INCORPORATED COUNTY OF LOS ALAMOS

Invitation for Bids No. IFB24-16
IFB Name: White Rock Visitor Center Restrooms and Pavilion

Addendum No. 1

SHEET
E-101

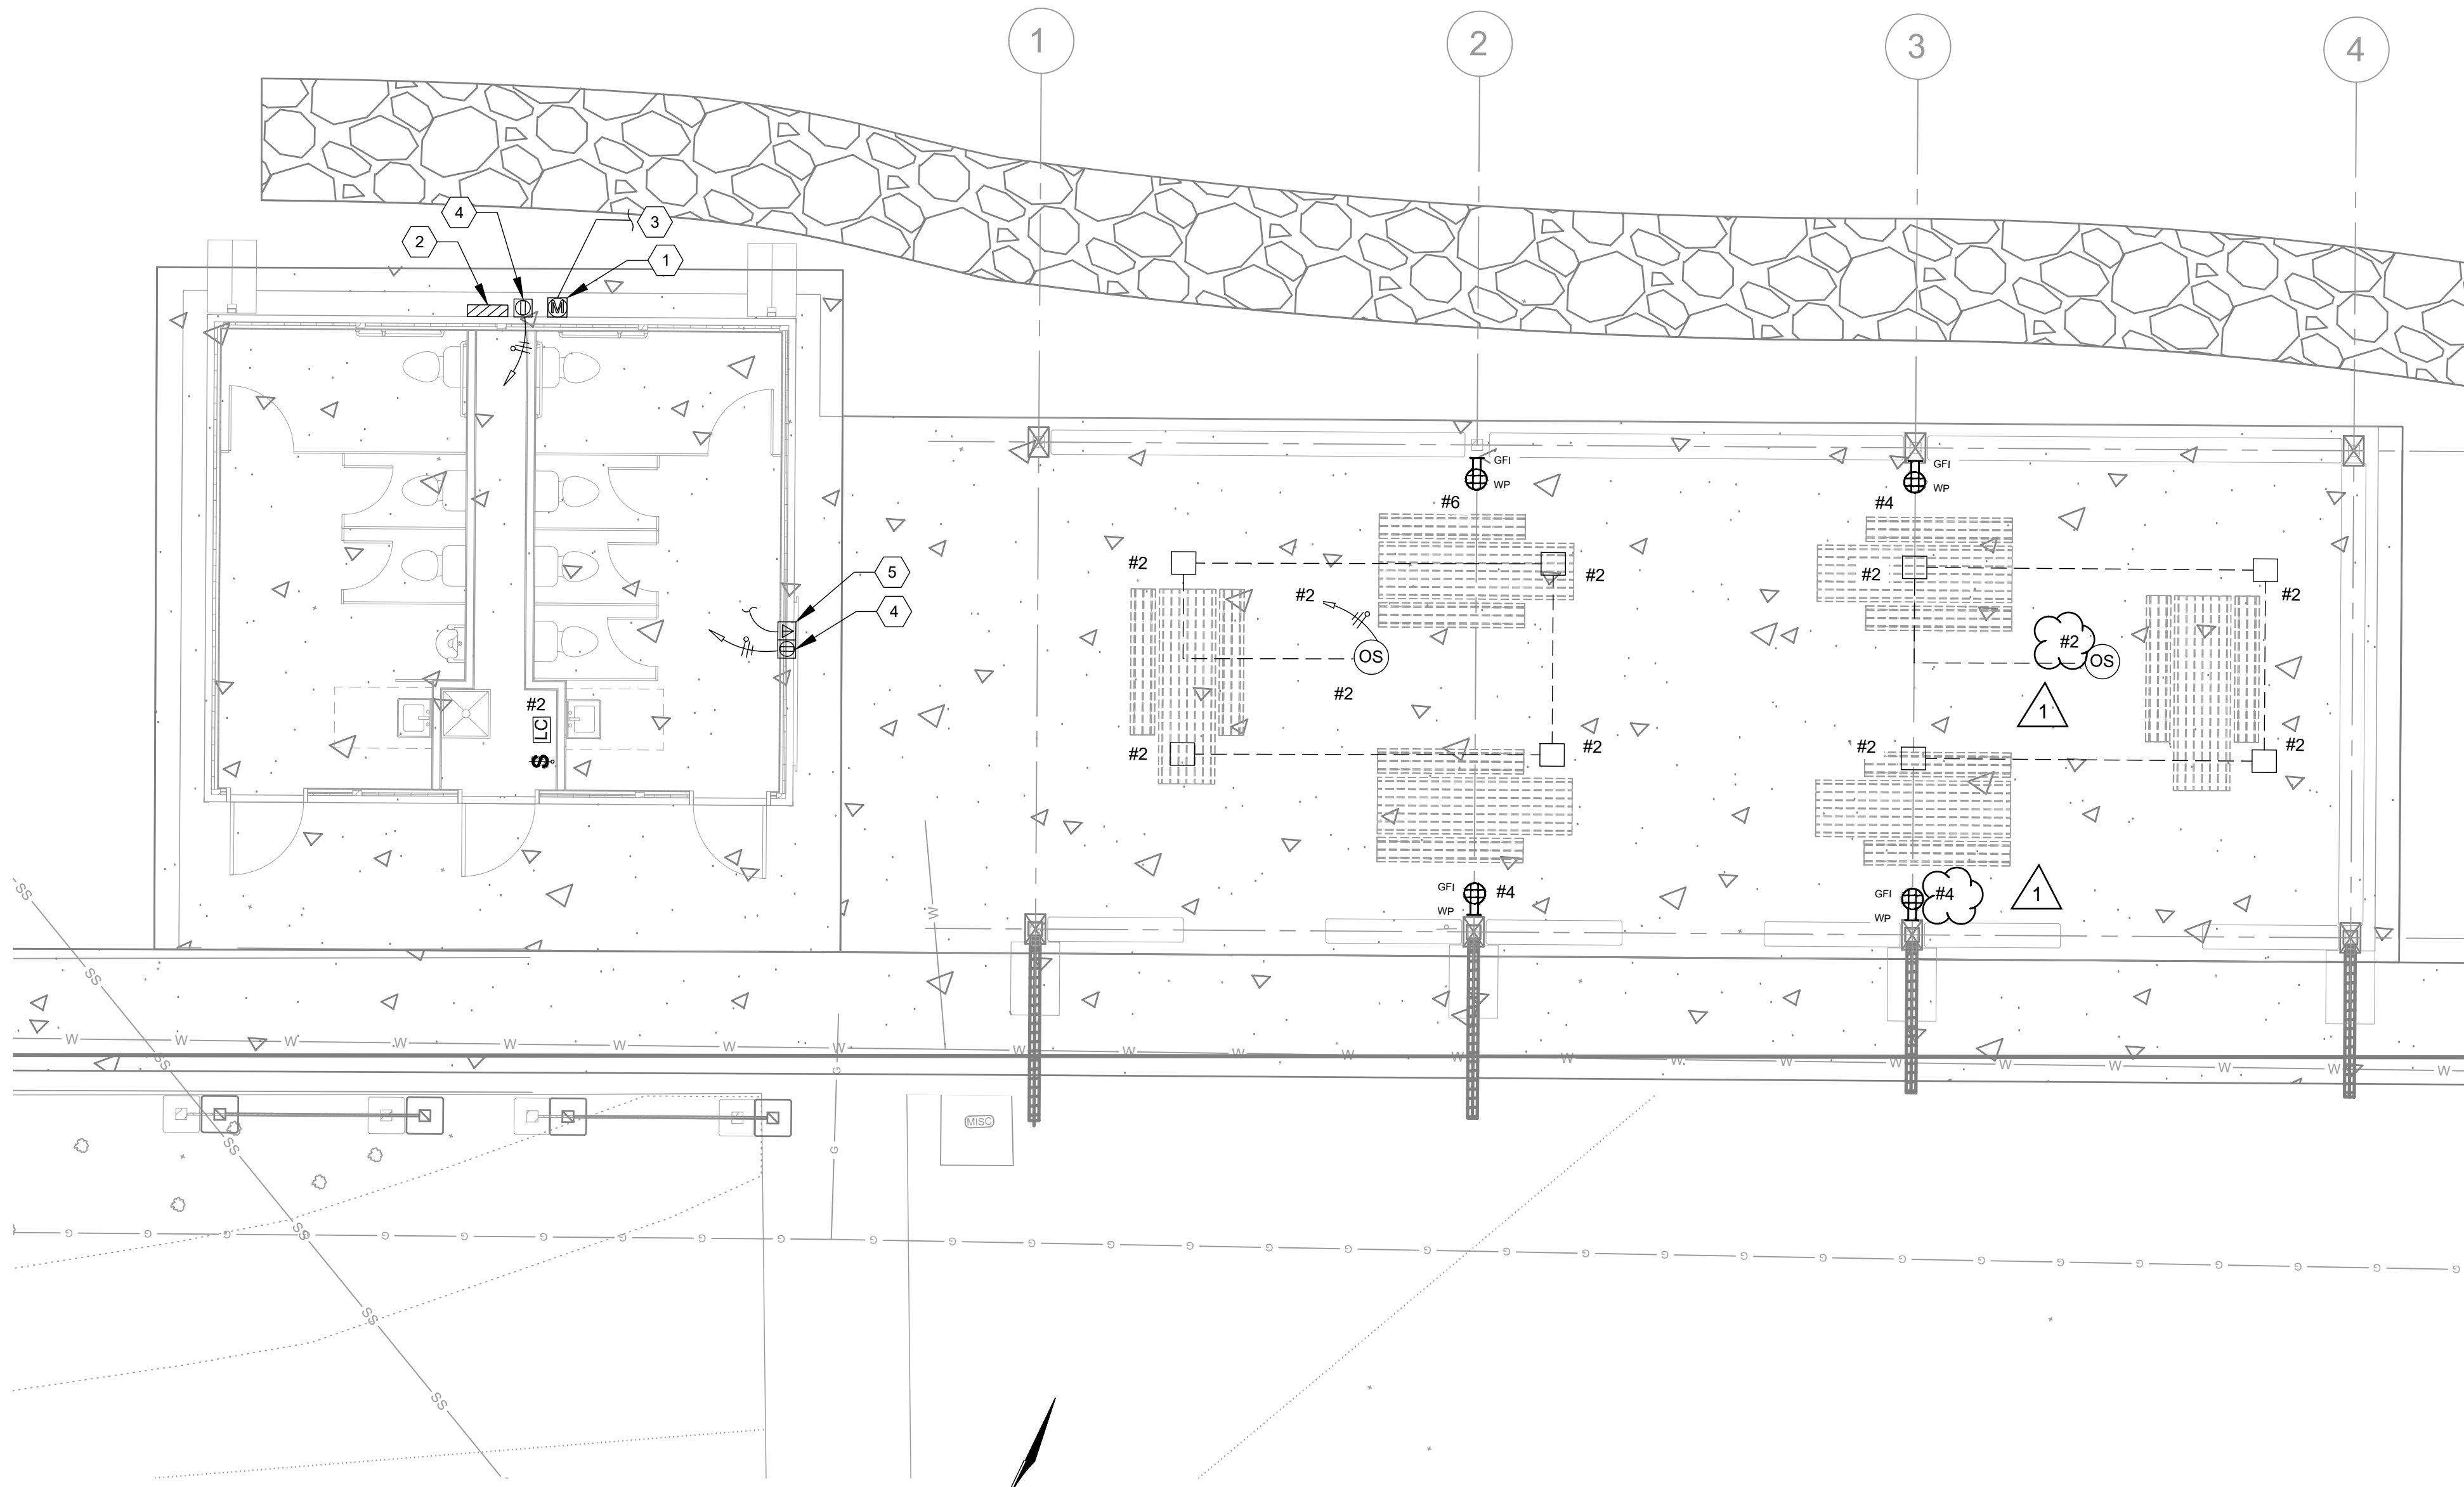
NO.	REVISION DESCRIPTION	DATE	BY
5			
4			
3			
2			
1	ADDENDUM NO. 1	11/17	CL
